SUBJECT: Confirms 840328 telcon re post-accident sampling sys,
 Modified sys installed, tested, functional & in compliance
 w/TMI Action Item II, B.3 & License Condition 13.

March 28, 1984
G02-84-177

Subject: SUPPLY SYSTEM NUCLEAR PLANT NO. 2
POST ACCIDENT SAMPLING SYSTEM MODIFICATIONS

ORIGINAL SYSTEM DESIGN
Figure 1

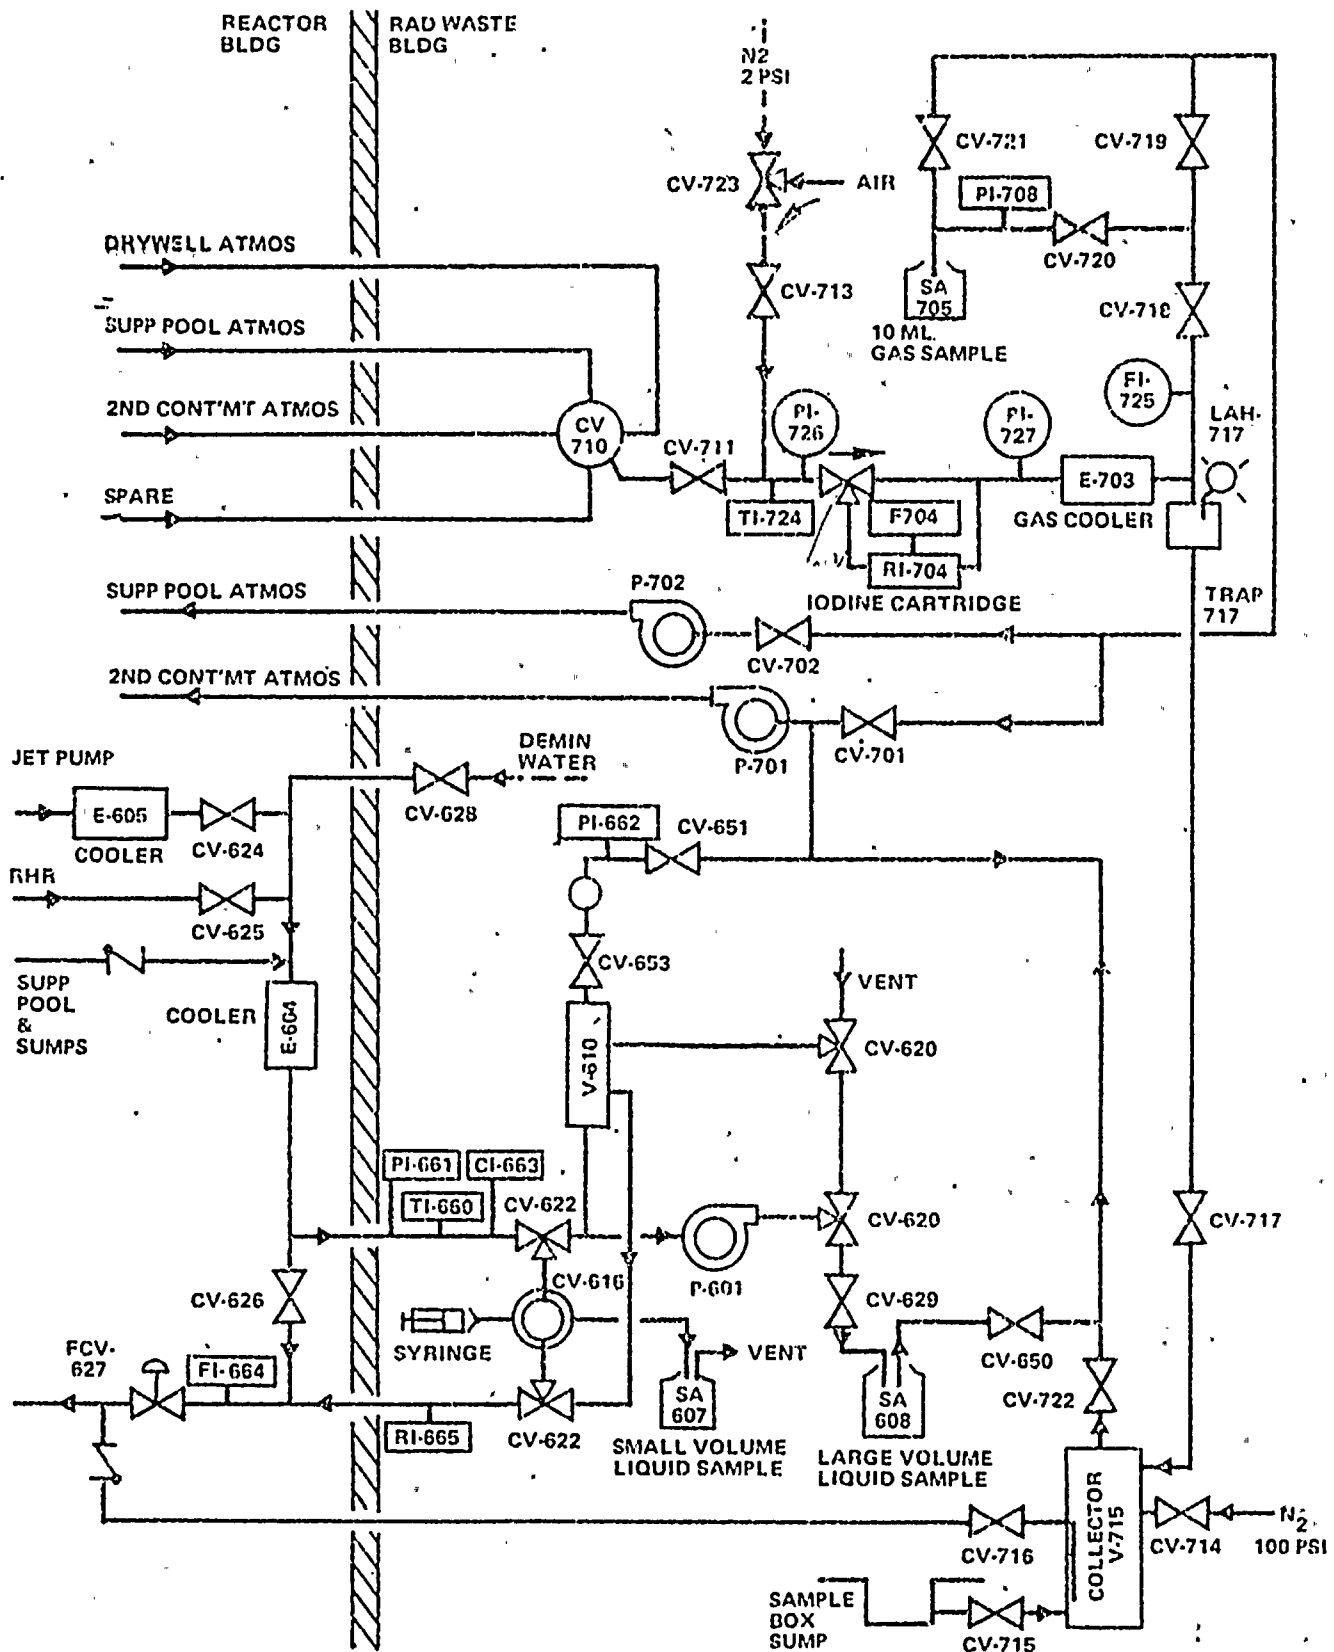
As we have discussed, the Plant 2 PASS (Fig. 1) was recently modified based on recommendations from the General Electric Company and the BWR Owner's Group to enhance the system capability. The modifications were made to simplify the design, improve system operability and to improve dose projections (ALARA).

Figure 2

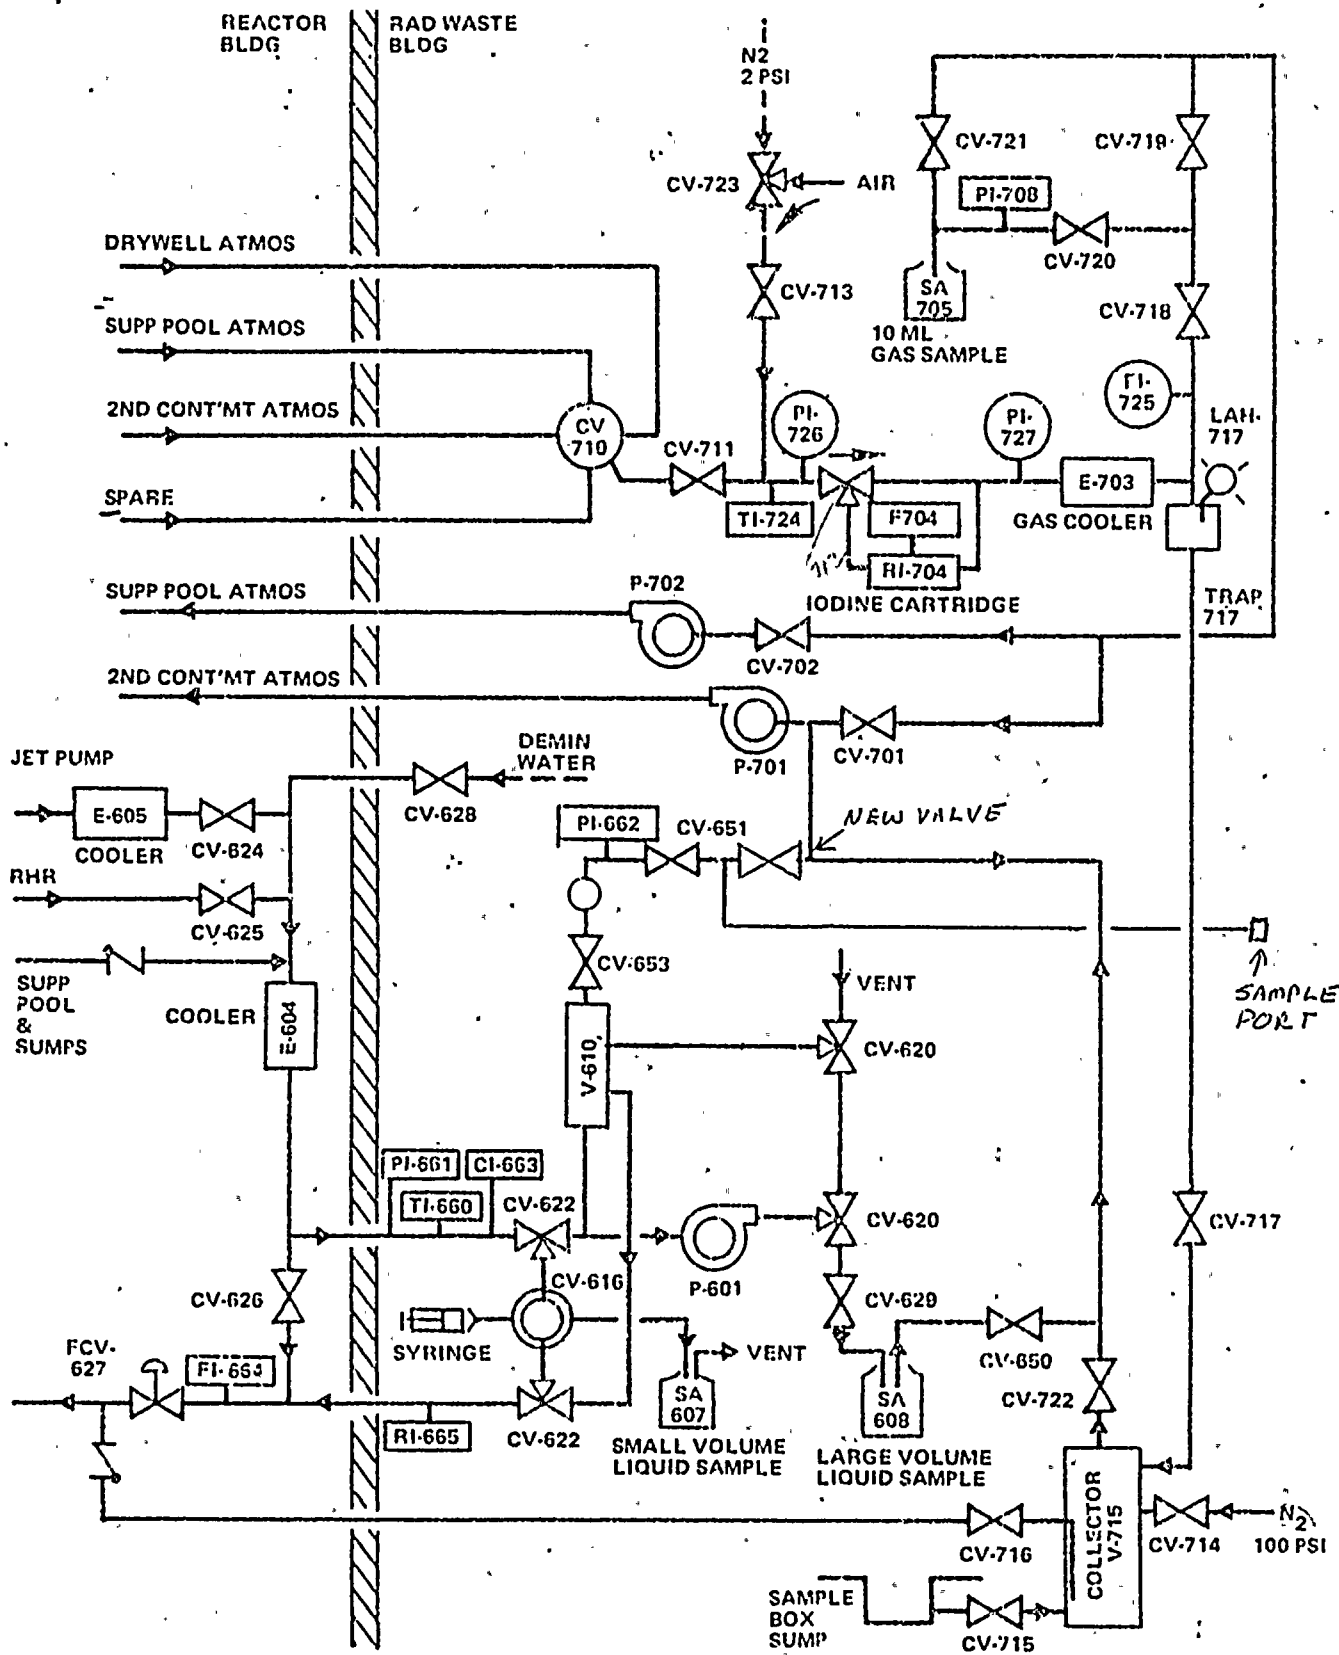
The modified system (Fig. 2) is presently installed, tested and functional. Our personnel have been trained in its operation and we feel that we are in compliance with the requirements of TMI action item II.B.3 and WNP-2 License Condition 13 (NPF-21).

As you are aware, the modifications eliminated the capability to obtain a grab sample of the reactor coolant for performing a dissolved gas analysis. While we do not feel that this capability is required to meet the above noted conditions, we have agreed that the grab sample capability will further enhance the system and will meet the recommendations of Regulatory Guide 1.97.

The capability to obtain the grab sample will be accomplished by adding a sample tap to the existing system as discussed with you today and as shown in Figure 3 (attached). This modification has been discussed with the NSSS vendor (General Electric Co.) and with our Architect-Engineer (Burns and Roe). The sample tap will be installed, procedures prepared, and personnel trained by May 1, 1984.
